UNITED STATES PATENT AND TRADEMARK OFFICE

APPLICATION NO.	FILING DATE	FIRST NAMED INVENTOR	ATTORNEY DOCKET NO.	CONFIRMATION NO.
10/531,295	11/15/2005	Cristiano Casale	1034170-000028	6251
21839 7590 10/20/2008 BUCHANAN, INGERSOLL & ROONEY PC POST OFFICE BOX 1404 ALEXANDRIA, VA 22313-1404				
EXAMINER TUCKER, DANIEL P				
ART UNIT 4159		PAPER NUMBER		
NOTIFICATION DATE 10/20/2008		DELIVERY MODE ELECTRONIC

Office Action Summary

DETAILED ACTION

Fig. 9 of US Patent No. 5,839,627 (Hicks et al. hereinafter)

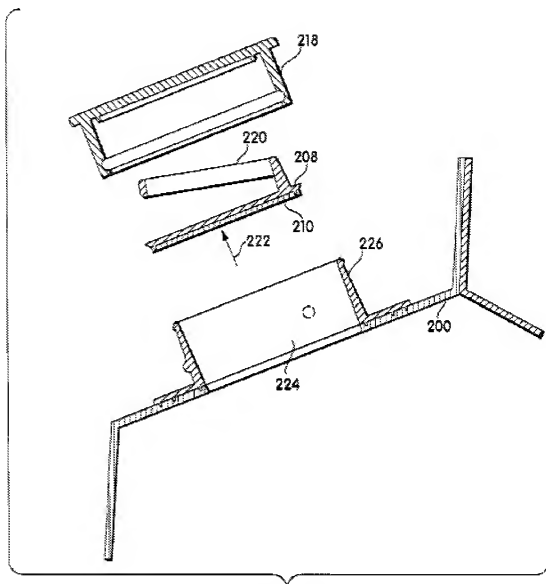
6. In re Claim 1, with reference to Fig. 9 above, Hicks et al. discloses:

A sealed package (200) for pourable food products,

- having at least one removable portion (210),

- and a closable opening device (218) in turn comprising a frame (226) defining a pour opening (224) and fixed to said package (200) about said removable portion (210),
 - a cap (218) fitted to said frame (226) to close said pour opening (224) and movable to free the pour opening (224),
 - and pull-off opening means housed in said frame and comprising a rigid plate (208 and 220) integral with said removable portion (210) and extractable from the frame (226), by pulling action (arrow 222), together with at least part of said removable portion (210); ~~characterized by also comprising a pull tab of sheet material interposed between said removable portion and said plate and attached to both.~~
7. Hicks et al. does not disclose a pull tab of sheet material interposed between the removable portion and the plate and attached to both.

12. In re Claim 4, with reference to Fig. 9, Hicks et al. discloses that said plate (208, 220) comprises a base portion (208) attached to said pull tab; and a grip portion (220;) projecting from said base portion (208) and accessible through said frame (226) when said cap (218) is removed from said pour opening (224).

14. In re Claim 9, with reference to Fig. 9, Hicks et al. discloses that said plate (208, 220) comprises a base portion (208) attached to said pull tab; and a grip portion (220) projecting from said base portion (208) and accessible through said frame (226) when said cap (218) is removed from said pour opening (224).

15. In re Claim 12, with reference to Fig. 9 above, Hicks et al. discloses that said grip portion (220) is substantially ring shaped (col. 5, line 4), projects from one end of said base portion (208), and is bent over the base portion (208).

27. In re Claim 11, with reference to Fig. 9 above, Hicks et al. discloses that said grip portion (220) is substantially ring shaped (col. 5, line 4), projects from one end of said base portion (208), and is bent over the base portion (208).

Fig. 7 of Hedberg

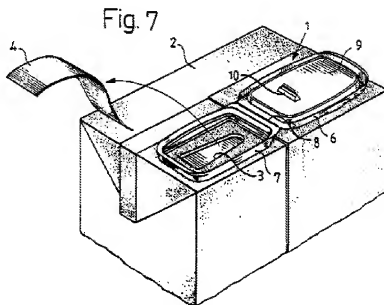
8. However, with reference to Fig. 6 and Fig. 7 above, Hedberg discloses a pull tab (4) of sheet material.

9. Therefore it would have been obvious to one having ordinary skill in the pertinent art at the time the invention was made to have modified the package disclosed by Hicks et al. to have a pull tab of sheet material as taught by Hedberg for the predictable result of sealing the opening and connecting the rigid plate to the removable portion.

Fig. 1A of Hicks et al.

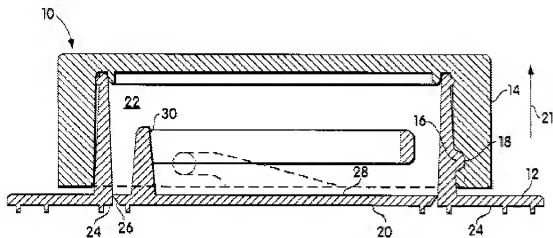
11. In re Claim 3, with reference to Fig. 1A above, Hicks et al. discloses that said plate (20, 28, 30) is connected integrally to said frame (12) by breakable connecting means (23, 24; col. 5, lines 7-12) defining a parting direction in which said plate (20) is parted from the frame (12), and which is parallel to the opening direction of said pull tab.

13. In re Claim 8, with reference to Fig. 1A above, Hicks et al. discloses that said plate (20, 28, 30) is connected integrally to said frame (12) by breakable connecting means (23, 24; col. 5, lines 7-12) defining a parting direction in which said plate (20) is parted from the frame (12), and which is parallel to the opening direction of said pull tab.
